Addendum to H-58-14-AMAM-01 Engine Mount Fittings

Borescope Inspection shall be completed by a Technical Inspector

Access to the 406-030-142-101 (L/H Engine Mount Fitting)

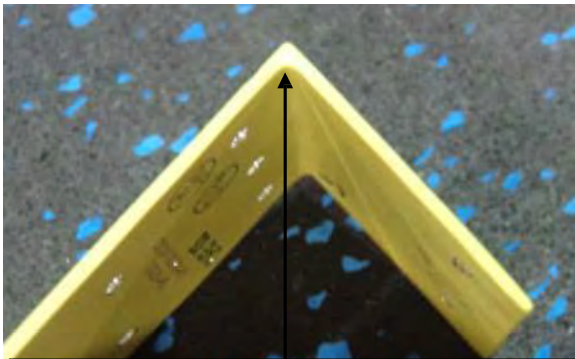
Inspection area is interior to engine deck gunwhale adjacent to the bolt hole for the left and right forward lateral engine mount legs. Refer to TM 1-1520-248-23&P (EM0246) WP 0930 figure 2, item 28 for orientation.

Access to the 406-030-142-102 (R/H Engine Mount Fitting) can be accomplished through the right hand Avionic Compartment door.

Non-Conforming: No Fillet Radius,
90 Degree sharp edge

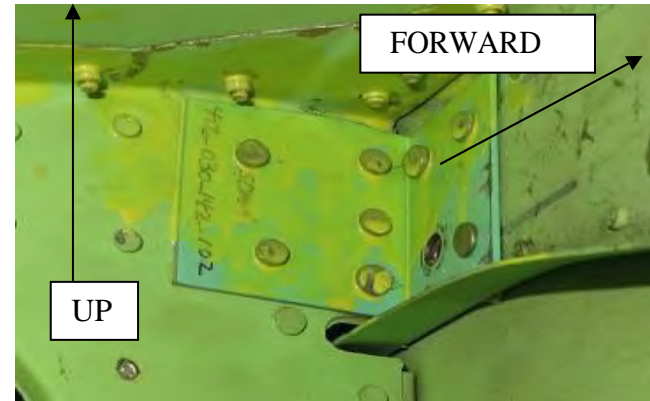
Non-Conforming: No Fillet Radius OR Bell Helicopter (bh) Stamp
(recent install)
